ADDENDUM TO: INSTALLATION INSTRUCTIONS FOR VISTA-100

USE WITH ISSUES: N6019-2

RE: BATTERY HARNESS NOTE

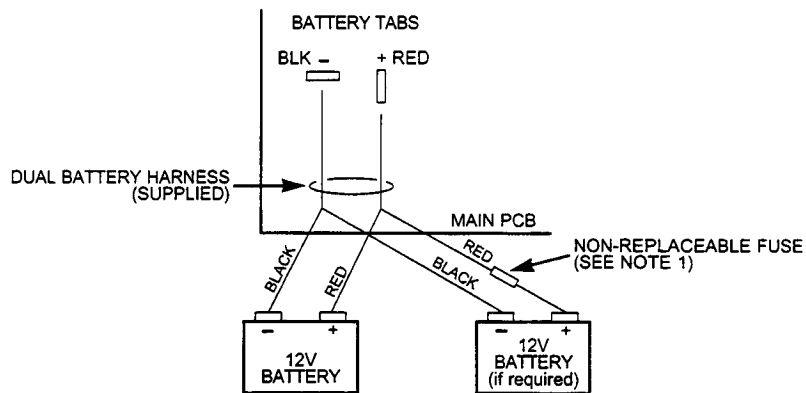
The Vista-100 comes with a dual battery harness, which allows up to two 12V sealed lead acid batteries to be connected in parallel to the control. Connect the battery(s) to the control using the dual battery harness as shown in the figure below. When two batteries are used, mount them as instructed in the *FINAL POWER-UP PROCEDURE* section of the Vista-100 Installation Instructions. Also, be sure to follow the installation instruction notes about connecting batteries in parallel.

Note 1: This fuse is intended to prevent the risk of battery harness flame-out when two batteries are used and one battery is connected with proper polarity and the other is connected with reversed polarity. This fuse will not open circuit under any other condition. Observe proper polarity when making connections.
